Certificate of Appropriateness Request:

H-16-24

65 Union St N

Staff Report prepared by:

driveway and retaining walls

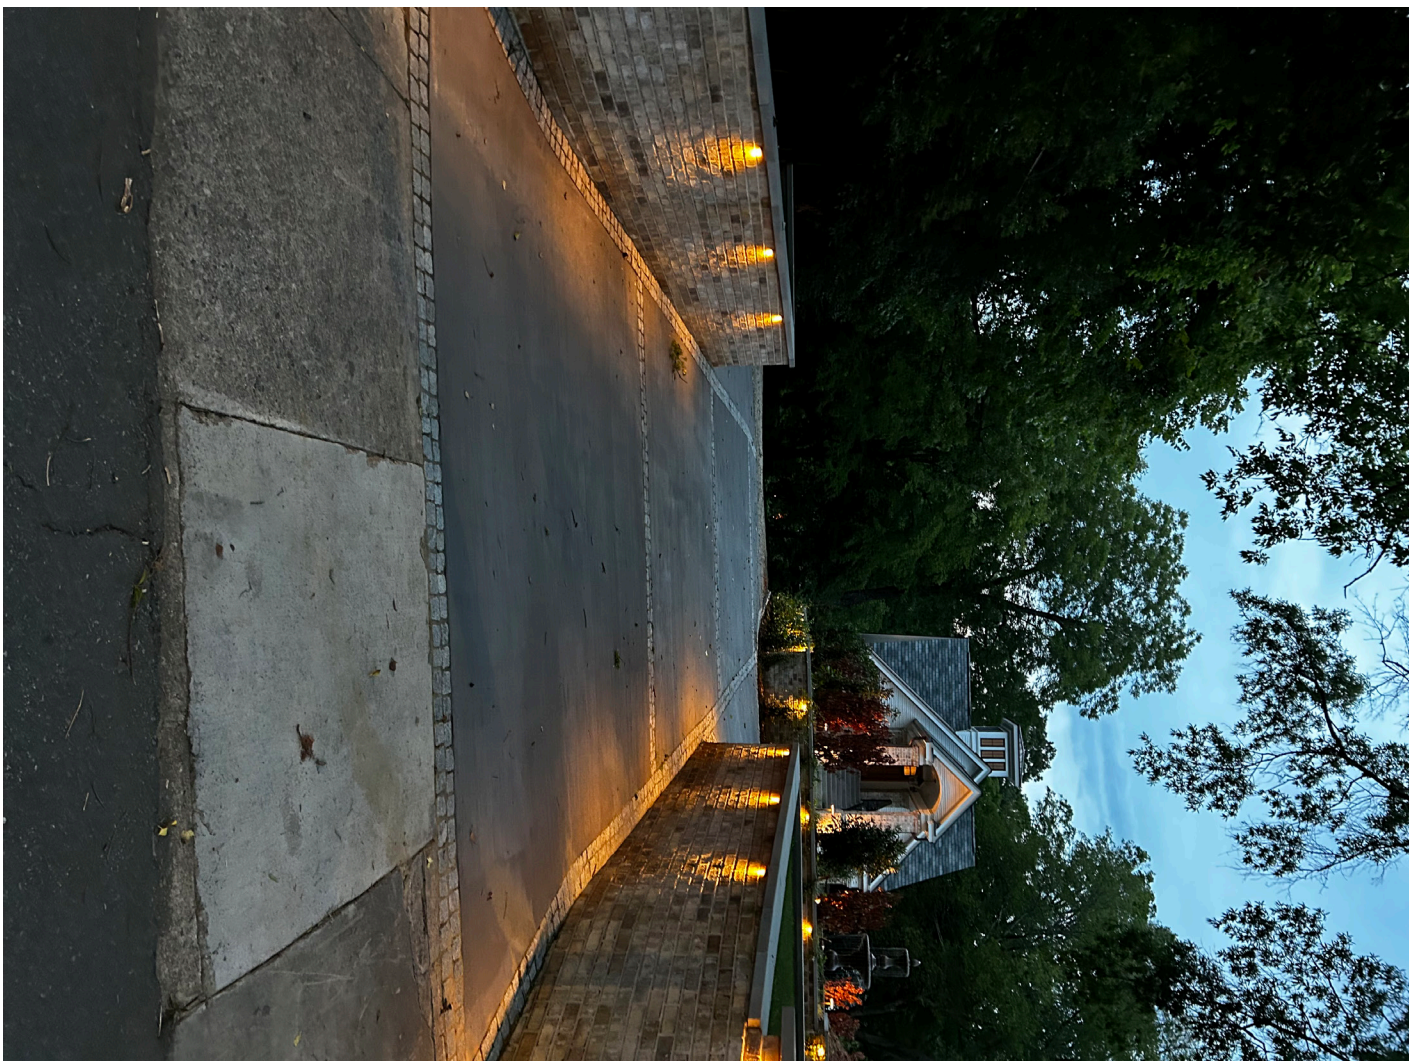
- **Brick retaining walls at the entrance off of Grove Ave.** During grading, the applicants found that due to topography, these were needed to retain the earth on either side of the driveway. These match the height and brick material of the adjacent brick retaining walls that were approved and installed.
- **Low level/landscaping lighting installed within these retaining walls.** These lights were included for the applicant's security as well as to help with visibility along Grove Avenue as this section of roadway is very dark and, up to recently, did not have a working streetlight.
- **Water fountain.** Fountains are a typical feature found in historic backyard gardens and this one helps to diffuse the sounds of traffic coming from Grove Avenue. The applicants didn't realize this needed HPC approval.

- **Part of the new driveway off of Grove Avenue is installed with concrete and cobblestone inlays, instead of the approved pea gravel.** Pea gravel was installed but the applicant found that the pea gravel in the section of the driveway at the entrance to Grove Avenue was washing into the road and cars were kicking the gravel out into the street. The existing driveway and parking area off of Grove Avenue is paved with concrete.

- **Steps leading to the 2<sup>nd</sup> story of the accessory structure are concrete and not the approved bluestone.** The applicants state that concrete steps are more safe and appropriate to the era, and more suited to the environment.
